TO: All Proposers  
FROM: Lauren Rowley, Purchasing Manager  
DATE: **March 03, 2026**  
SUBJECT: **Addendum #01 – P26000527: UTAH DAM CLEANING**

**This addendum has been issued to address the following vendor Q&A:**

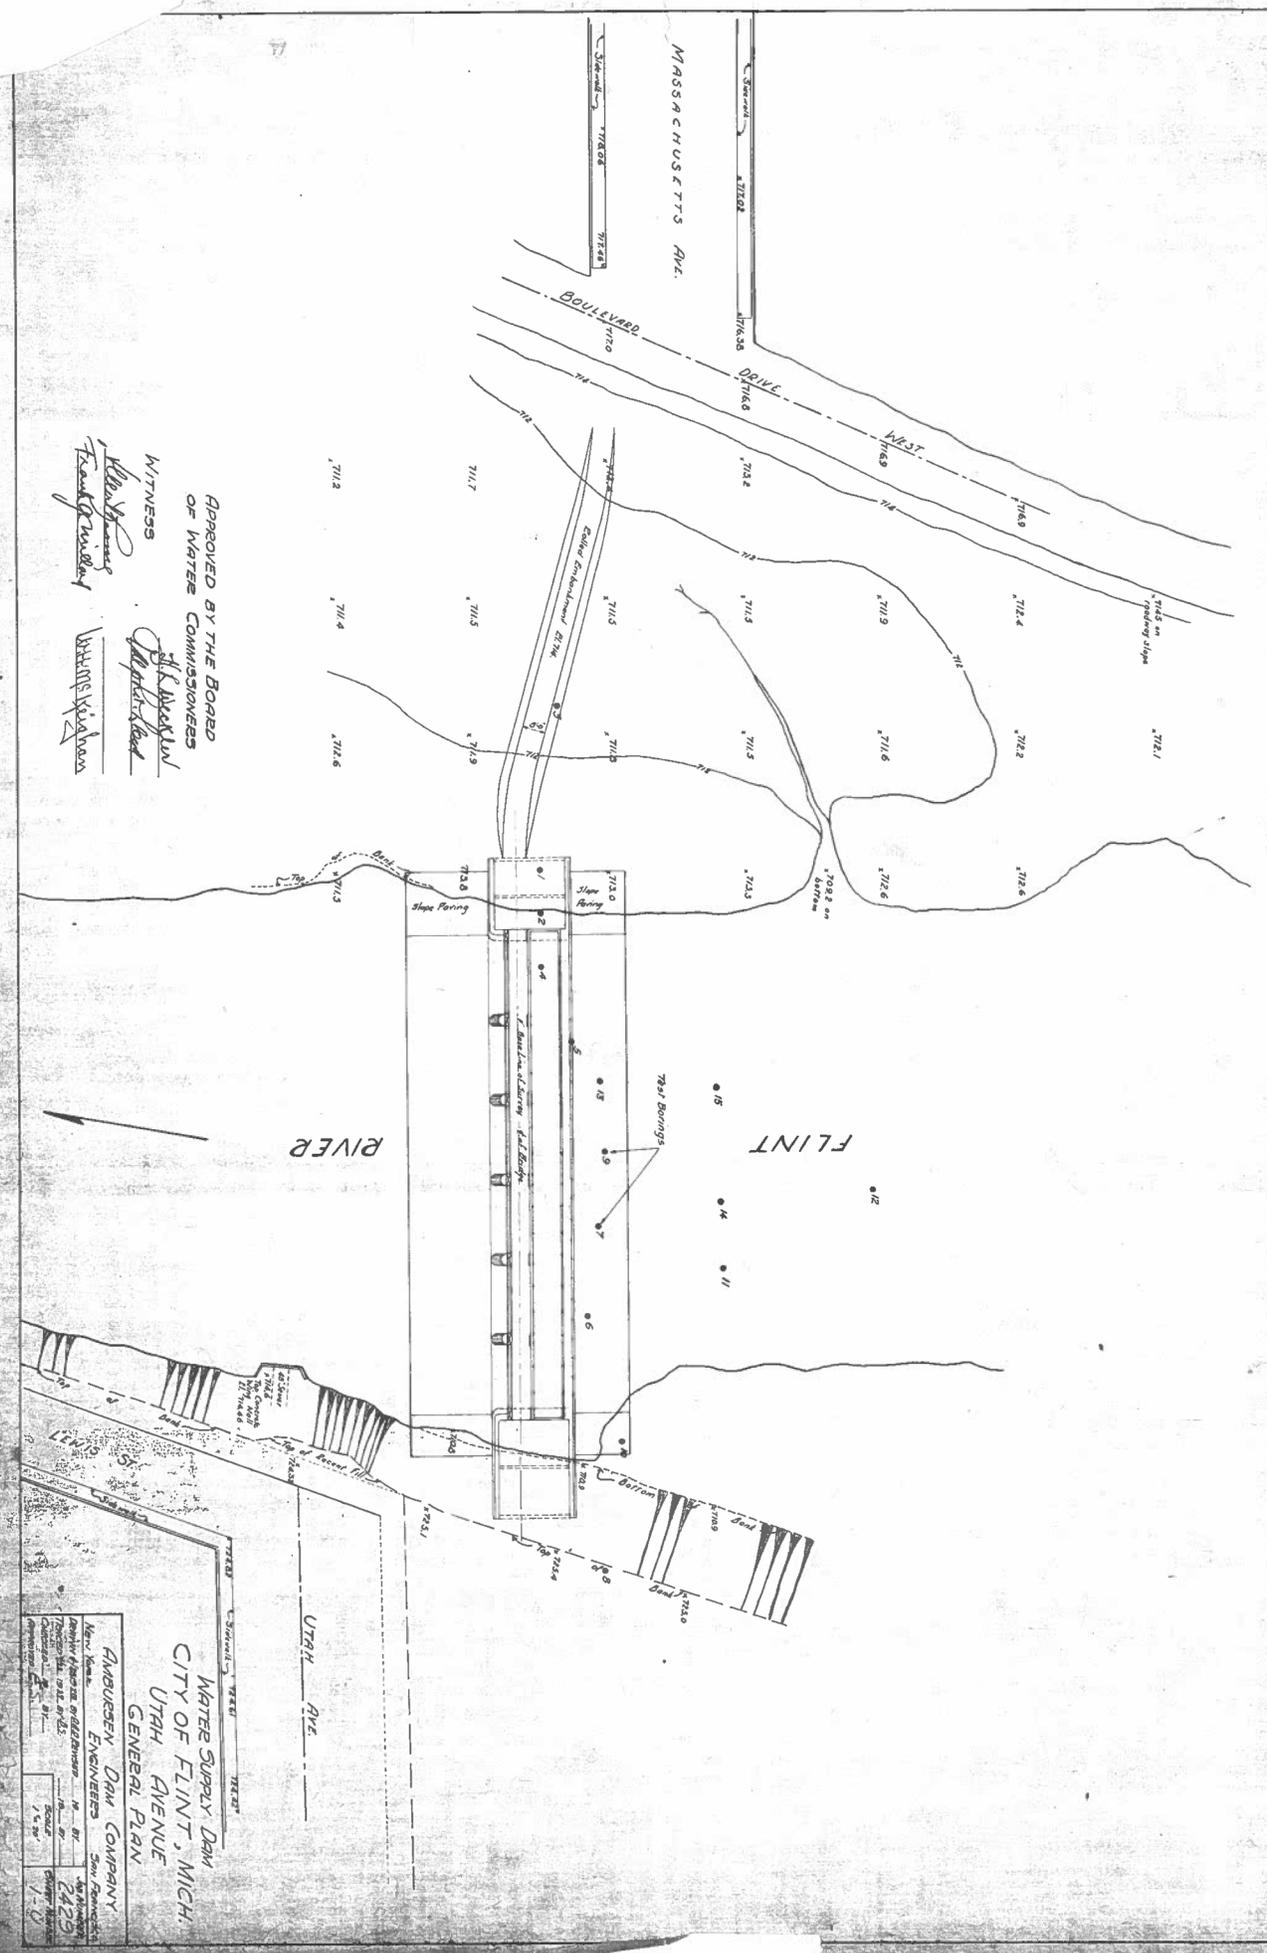
**Q1.) Please identify the extent of shore clearing that shall be included in the scope of work on the east and west sides of the dam bridge.**

**Q39.) What are the limits for removal? IE 20ft upstream of the structure and to what depth is the contractor being asked to remove to? Will this include any material within the gate structure/guide slots?**

**A1.)** Property marked plus an overhead aerial photo was attached.

A39.) An aerial map shows the approximate area and the city has marked the property with paint and flags and anything inside the markings needs to be removed. Only floating material on top of the water needs to be removed, if you can grab it with your hand pull it out.
